Access Compliance Report

Public Rights-of-Way

Intersection ID: 44419	Main Street: ARDREY_KELL_RD	Cross Street: PROVIDENCE_RD	Location: SE
ADA ID: 8DDF4F448967	Ramp Type: Perpendicular	Initial Pass/Fail: Fail	Overall Compliance: No
		Severity Score: 8.75

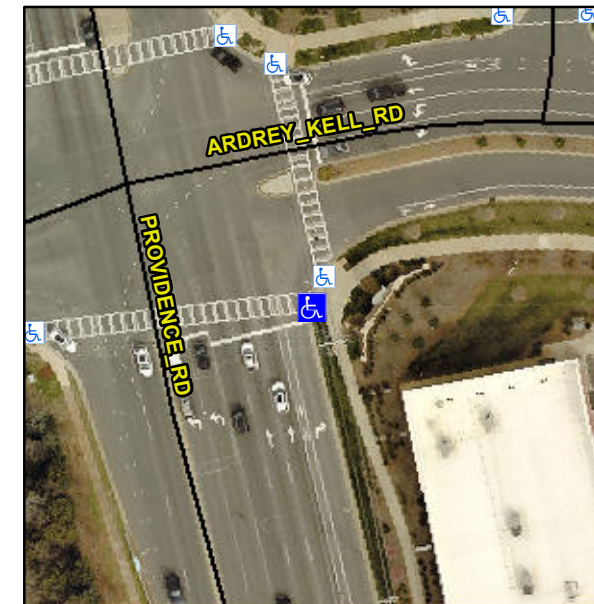
Not Found, R304.5.1

Compliance	Description	Data	Compliance	Description	Data
N/A	Ramp Length (in)	93.0	Yes	Ramp Slope (%)	8.2
No	Ramp Width (in)	47.5	Yes	Ramp XSlope (%)	2.0
N/A	Flare Type LT	N/A	N/A	Flare Type RT	N/A
N/A	Flare Slope LT (%)	N/A	N/A	Flare Slope RT (%)	N/A
N/A	Flare Traversable LT?	N/A	N/A	Flare Traversable RT?	N/A
N/A	Landing Length (in)	N/A	N/A	DWS Provided?	N/A
N/A	Landing Width (in)	N/A	N/A	DWS Contrast?	N/A
N/A	Landing Slope (%)	N/A	N/A	DWS Length (in)	N/A
N/A	Landing X Slope (%)	N/A	N/A	DWS Full Width?	N/A
N/A	Landing Curb? (Y/N)	N/A	N/A	DWS Offset (in)	N/A
N/A	Shared Landing?	N/A			
N/A	Gutter Ponding?	N/A	N/A	Gutter Slope (%)	N/A
N/A	Gutter Lip Ht (in)	N/A	N/A	Gutter X Slope (%)	N/A
N/A	Painted X Walk1?	Yes	N/A	Painted X Walk2?	N/A
	X Walk 1 Direction	To W		X Walk 2 Direction	N/A
N/A	X Walk 1 Width (in)	112.0	N/A	X Walk 2 Width (in)	N/A
	X Walk 1 Slope (%)	4.9		X Walk 2 Slope (%)	N/A
	X Walk 1 X Slope (%)	2.4		X Walk 2 X Slope (%)	N/A

Remove & Replace Entire Ramp.
